GPU Nuclear

Subject: Oyster Creek Nuclear Generating Station
Docket No. 50-219
Core Spray Restart Modification

CORE SPRAY RESTART MODIFICATION

FIGURE 1 : CONCEPTUAL ELEMENTARY FOR COFE SPRAY CONTROL LOGIC MODIFICATION (Ch. A)

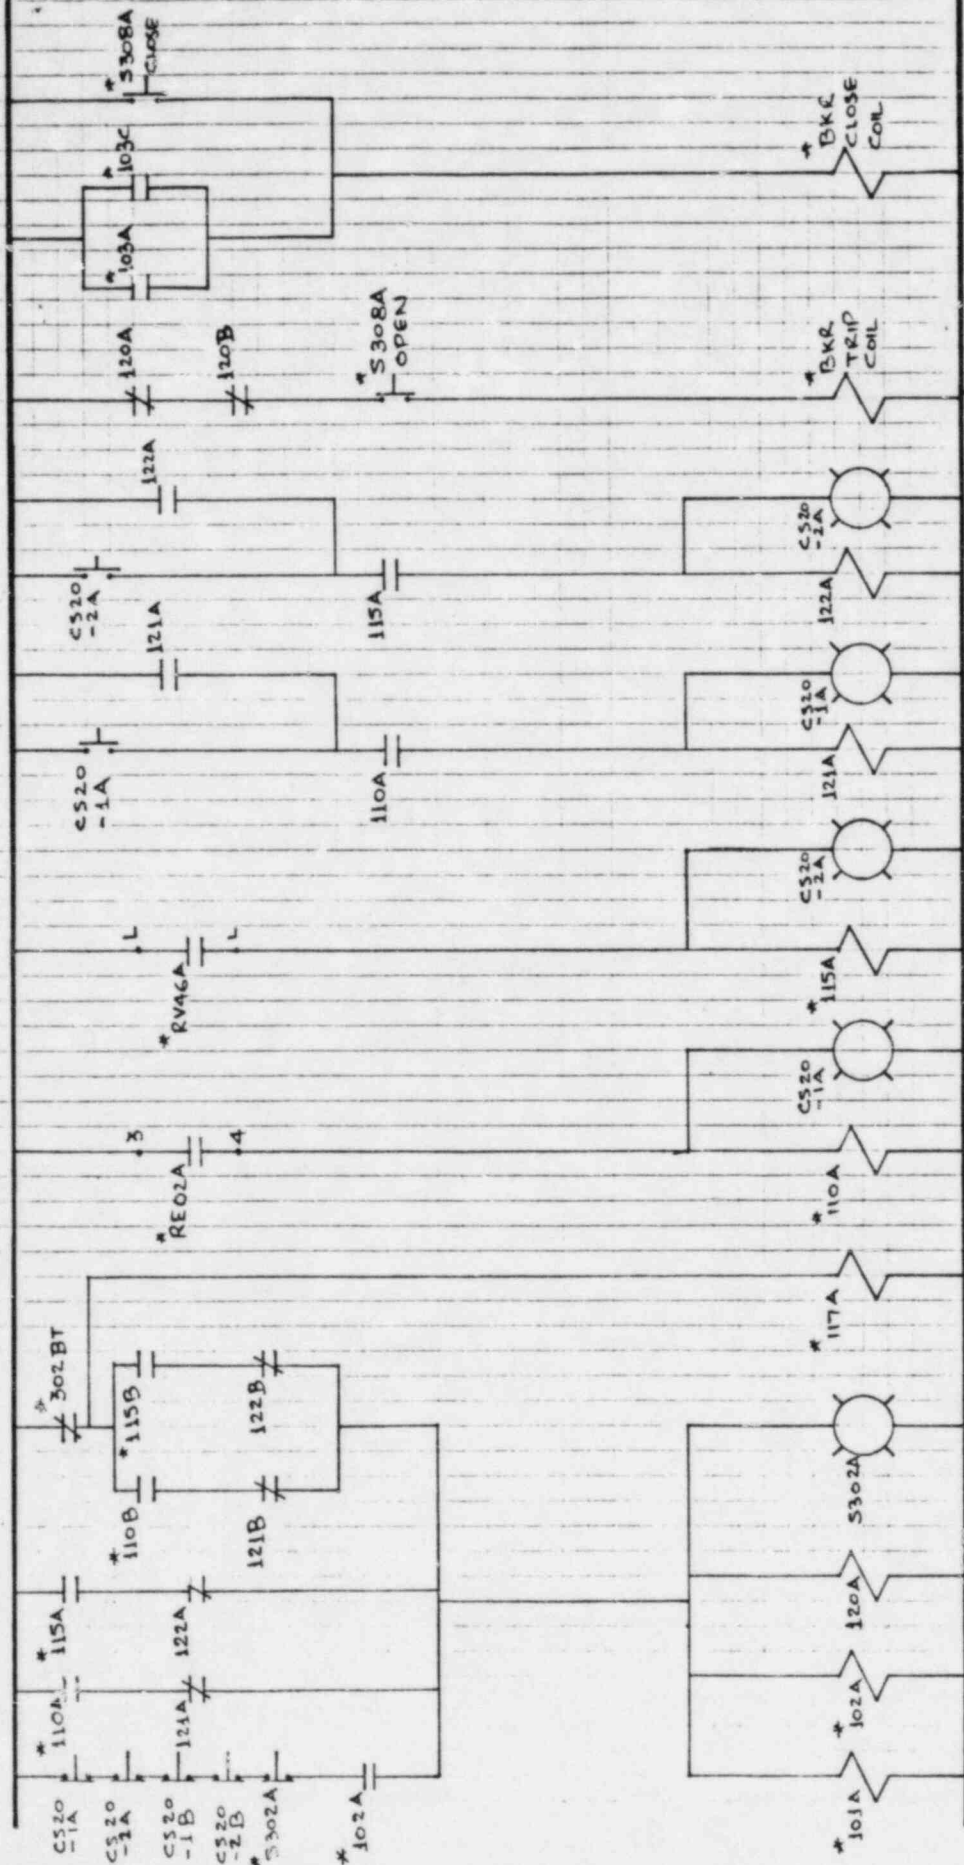
The conceptual elementary diagram and the panel layout for the modification are shown in figures 1 and 3, which are attached.

The switch will be the momentary contact type. The switches and lights will be wired so that the top half of the switch will light up when the ECCS sensor trips. This will provide the indication of the tripped sensors in the control room. The switch will be wired to override the respective ECCS signal. The lower half of the back light will light up when the tripped sensor is in the override state. To put the core spray controls into the override (manual) mode, all tripped ECCS sensors have to be placed in override.

The next row of key operated switches will replace the existing "INHIBIT" switches 302 AT, 302 BT, 302 CT, and 302 DT. The function of these switches shall remain unchanged.

The bottom row of the backlighted switches will replace the existing "RESET" switches S302A, S302B, S302C and S302D. The light will provide the indication of the actuated logic channels. The switches will be used to reset the actuation logic after the ECCS signals clear.

Figure 3: Panel Layout For Core Spray Control Logic Modification

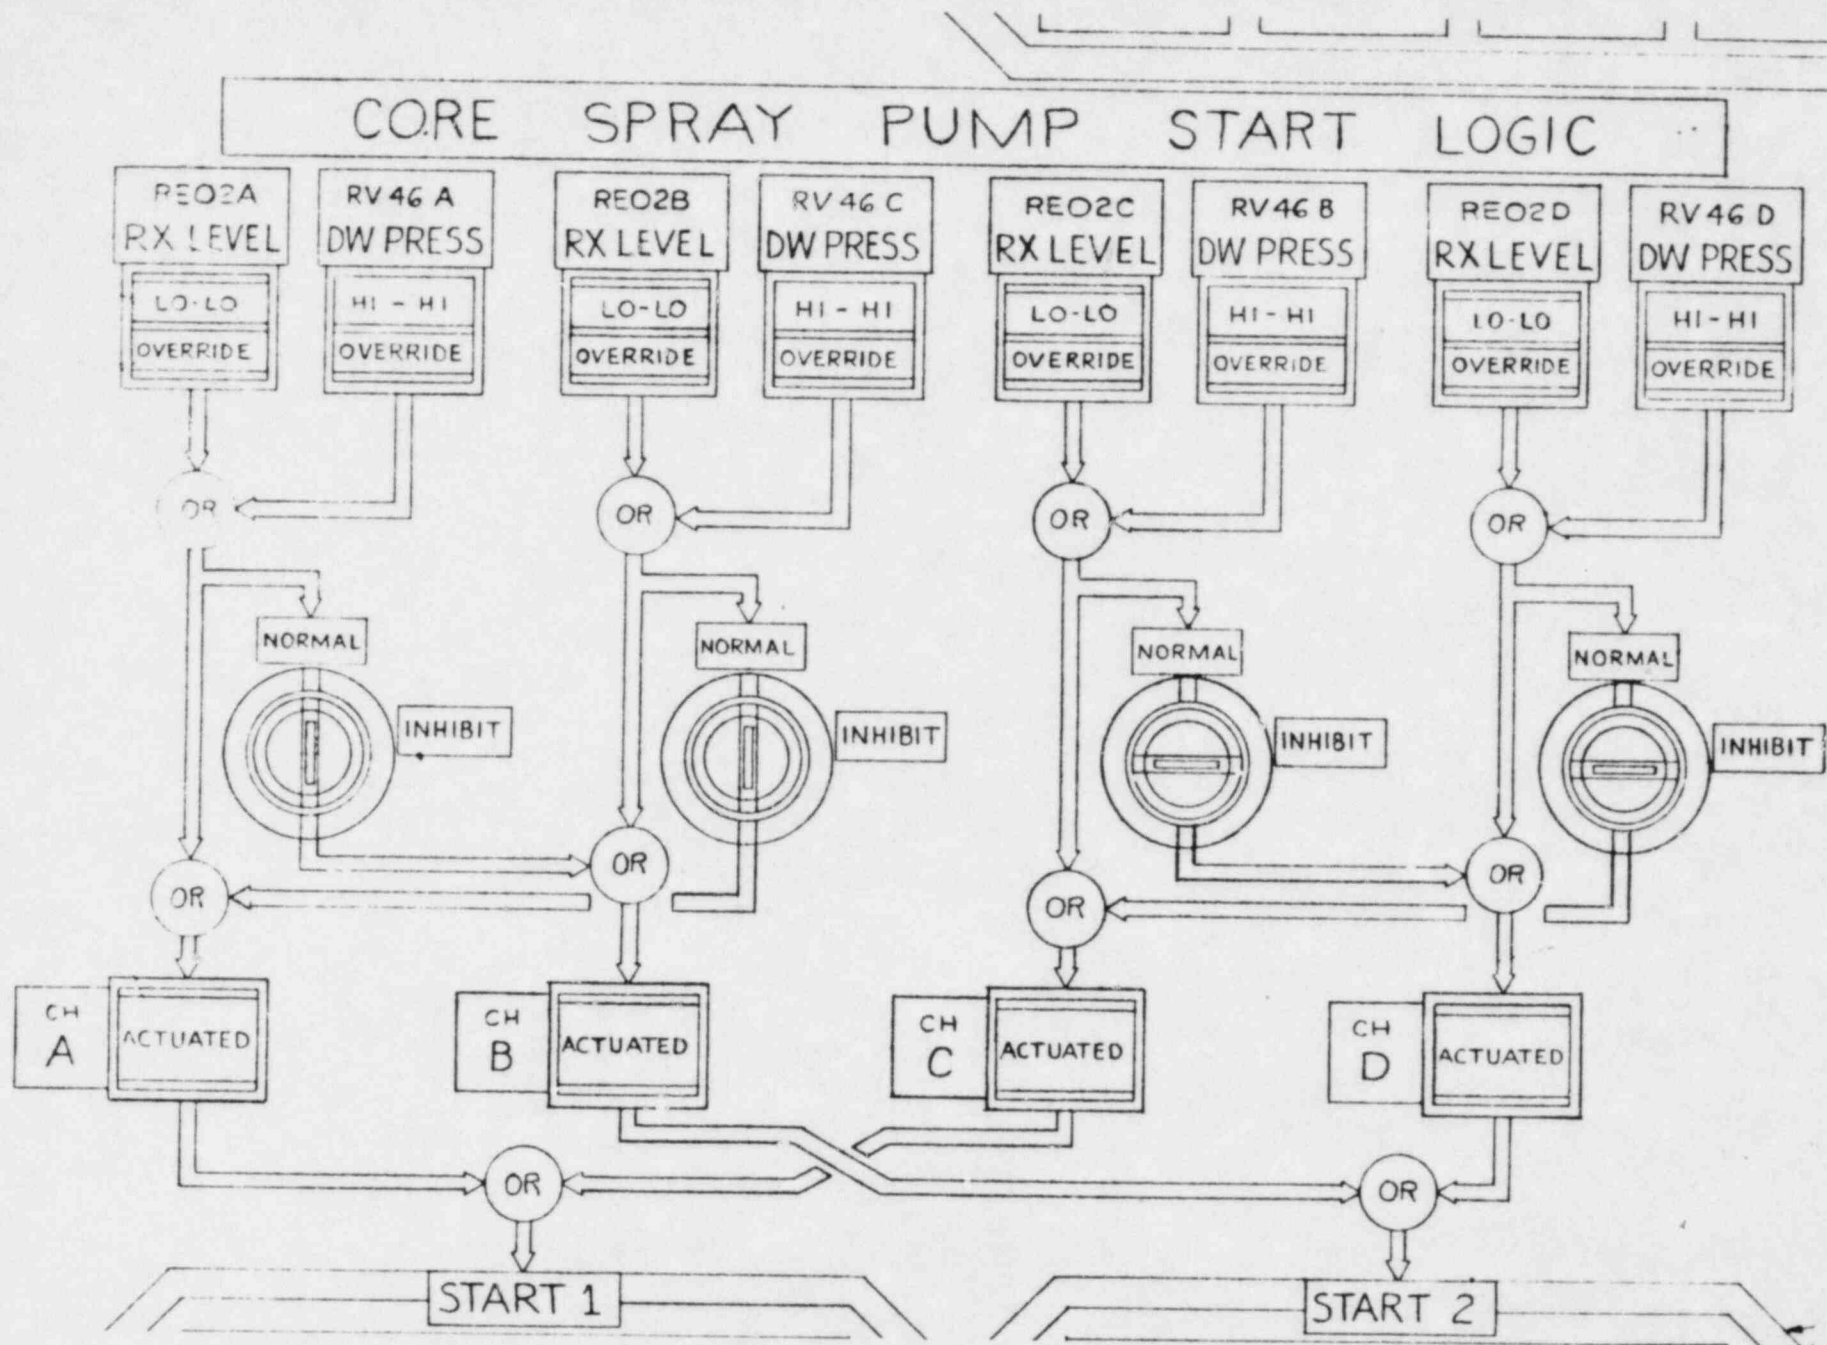
The core spray control logic mimic board is shown in Figure 3. The mimic board along with the existing controls on panel 1F/2F will be the primary man-machine interface with the system.

Twelve new backlighted switches will be installed on panel 1F/2F. Four existing inhibit switches will be replaced with new switches.

Four existing reset switches will be removed from panel 1F/2F and the openings blanked by putting in blanking plates.

The control switches 303A and 303B for the parallel isolation valves will be replaced with new, spring return to normal, three position switches. The new switches will be mounted in place of the existing switches.
